AGENDA REPORT

RE: **Public Hearing on a Report and Joint City and Agency Action On: (1) Agency Resolution Amending the Oakland Army Base Reuse Plan to Include the Revised Layout of the Freeway Auto Mall; and (2) A City Resolution Amending the Oakland Army Base Reuse Plan to Include the Revised Layout of the Freeway Auto Mall**

**Attachment B: December 18, 2007 Amendment to the
Oakland Army Base Reuse Plan**

Figure 3: Addendum Project Description

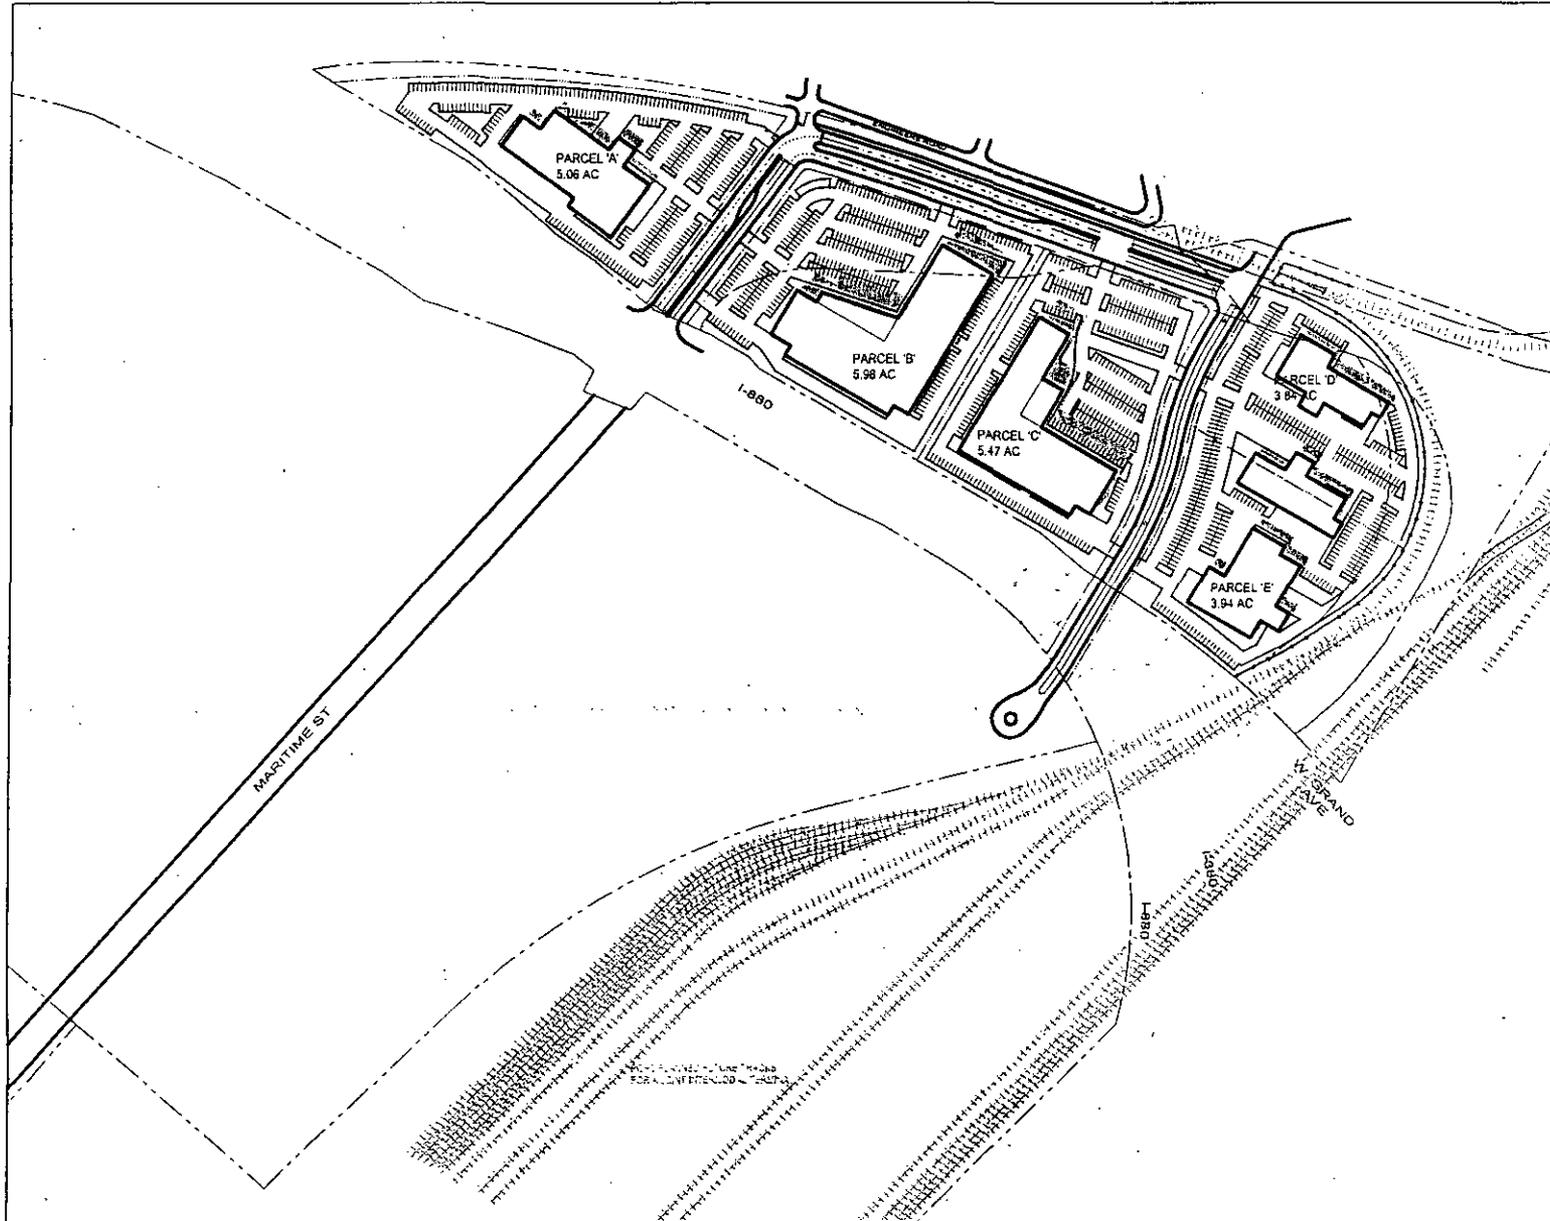
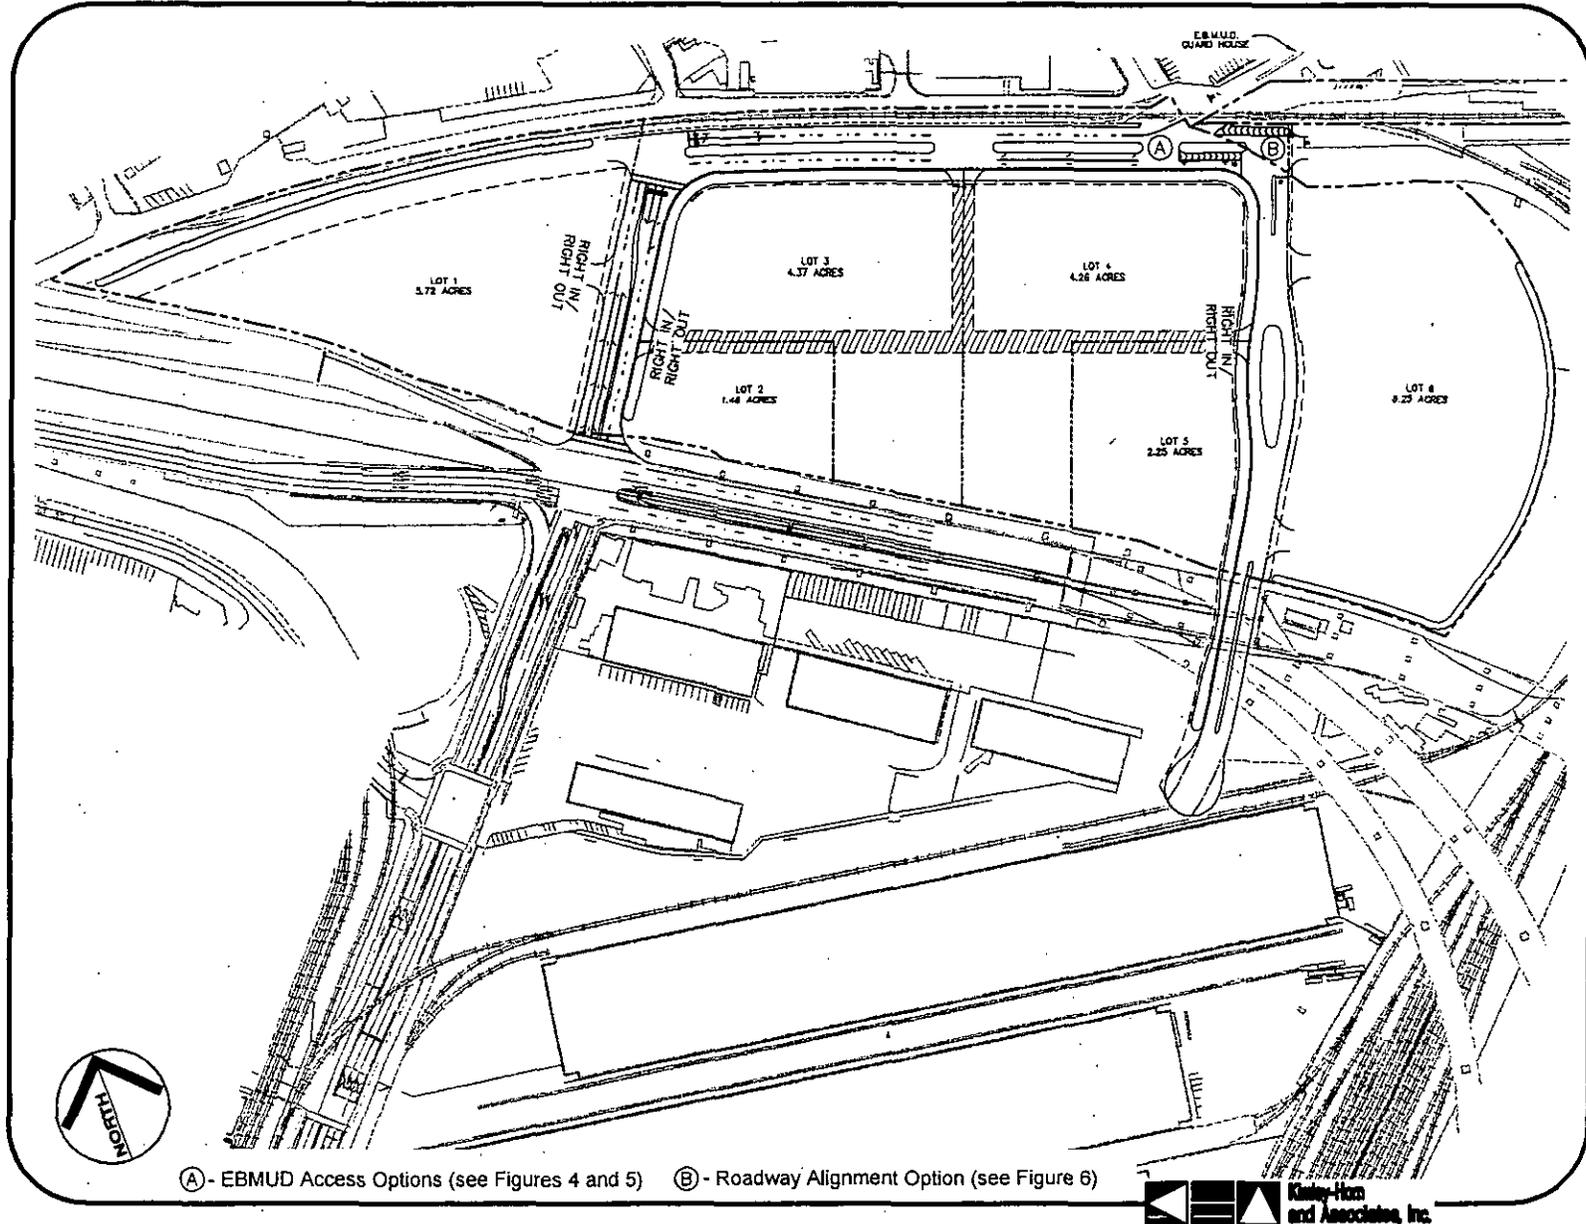
roadway. The Reuse Plan amendment would replace Figure 2-6 of the Draft Supplemental Environmental Impact Report for the Auto Mall project (which was added to the Reuse Plan in December 2006—refer to Attachment A above) with Addenda Figures 3, 4, 5, and 6. Although a final roadway alignment to serve the EBMUD facility has not yet been selected, Agency staff prefers the “two-lane Wake Avenue” configuration shown in Addenda Figure 4, because: (a) it provides a more continuous median with more landscaping in order to provide additional visual screening of EBMUD from the auto mall; and (b) our traffic engineering consultant has advised that this circulation approach offers the best level of traffic safety.

Attachment:
~~Auto Mall Project Conceptual Development Plan (Figure 2-6 of Draft Supplemental Environmental Impact Report for Auto Mall Project)~~

Auto Mall Project Conceptual Development Plans (Figures 3, 4, 5, and 6 of the First Addendum to the Supplemental Environmental Impact Report for the Oakland Army Base Auto Mall Project)

The 2006 Auto Mall project description in the SEIR consisted of developing four or five separate, approximately 5-acre sites into four or five automobile dealerships (with associated roadways and infrastructure improvements). The SEIR also included analysis of a Compact Design alternative that added an additional dealership (for a total of 6) on smaller-sized parcels, in structures up to four stories high. In both the SEIR Project and Compact Design alternatives, access to the dealerships would be provided via a new road (see Attachment A—Existing Auto Mall Layout).

Staff is currently considering an auto mall layout that is generally consistent with the Compact Design alternative: 6 separate dealerships on 6 separate parcels of approximately 2-6 acres each, at the same 4-story maximum height. The total building square footage for the Auto Mall project would remain at approximately 390,000 as indicated in SEIR, however project access points in the vicinity of the EBMUD facility which borders the Auto Mall project would change. Driveways would shift in location, access to and from driveways would be shared in certain circumstances, turning movements would be modified, and other possible intersection design options have been considered since preparation of the SEIR.

Figure 4: EBMUD Access - Dedicated Left Turn Lane Option

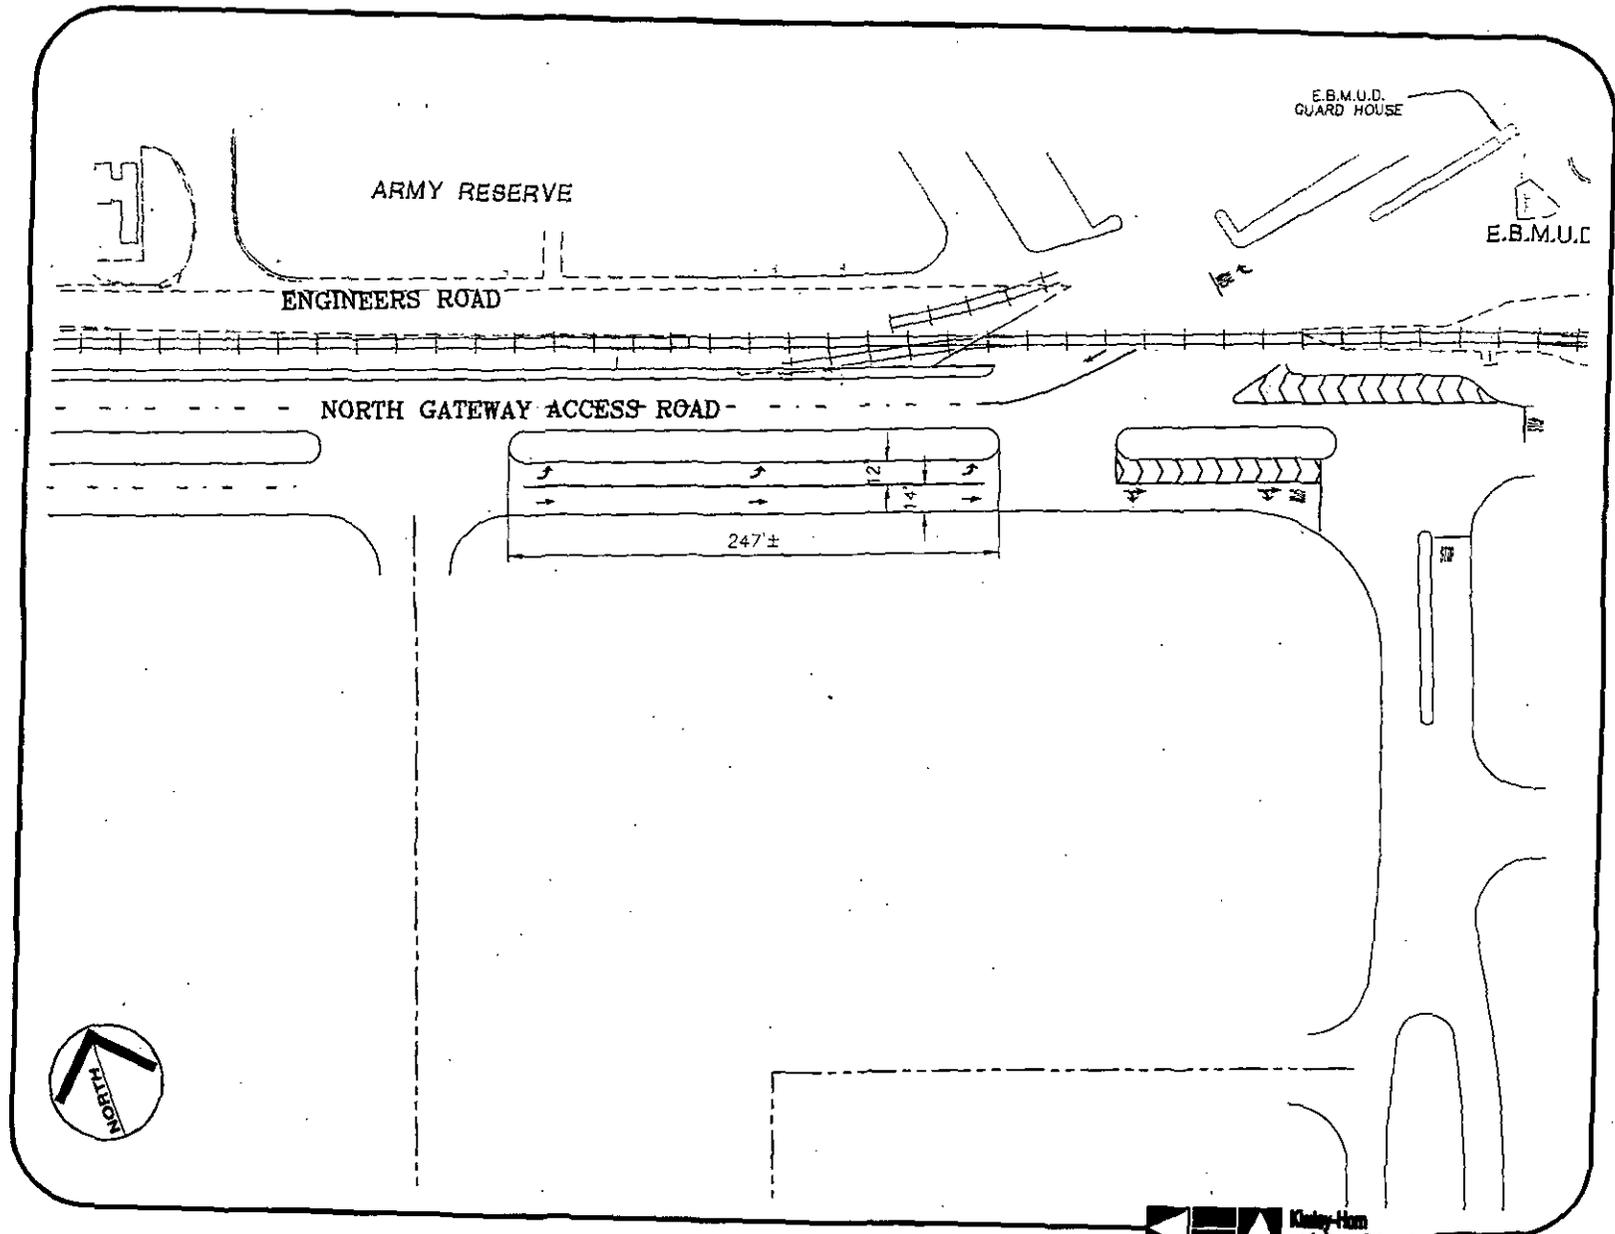
- Addenda Figure 3: “Addendum Project Description” (Attachment B1 of report)
- Addenda Figure 4: “EBMUD Access--Dedicated Left Turn Option” (Attachment B2)
- Addenda Figure 5: “EBMUD Access—Left Turn Pocket Option” (Attachment B3)
- Addenda Figure 6: Non-Port Dependent Roadway Alignment Option (Attachment B4)

Figure 3 provides a conceptual view of the overall North Gateway development layout, while Figures 4, 5 and, 6 provide greater detail of the road design at specific locations within the
